# OBLIVIOUS MONKEY GAMING

8070 MORGAN CIRCLE DRIVE SOUTH, BLOOMINGTON, MN 55431

TITLE SHEET

DEMOLITION PLAN - LEVEL 01

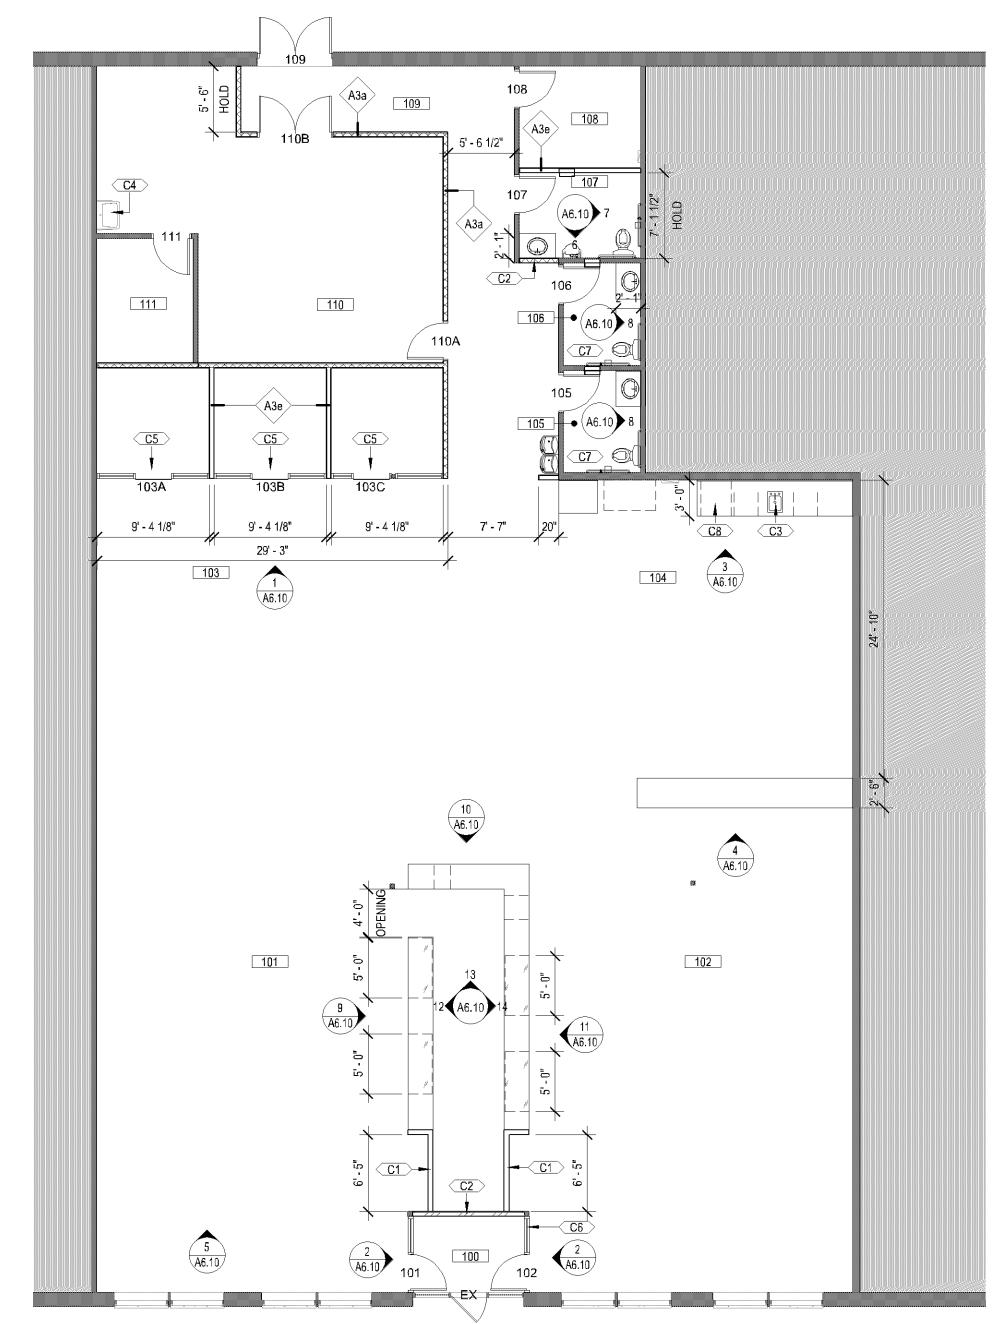
Entire space including individual booths (with ceilings) shall be sprinklered.

As an assembly occupancy, this space may be required to have a fire alarm system.
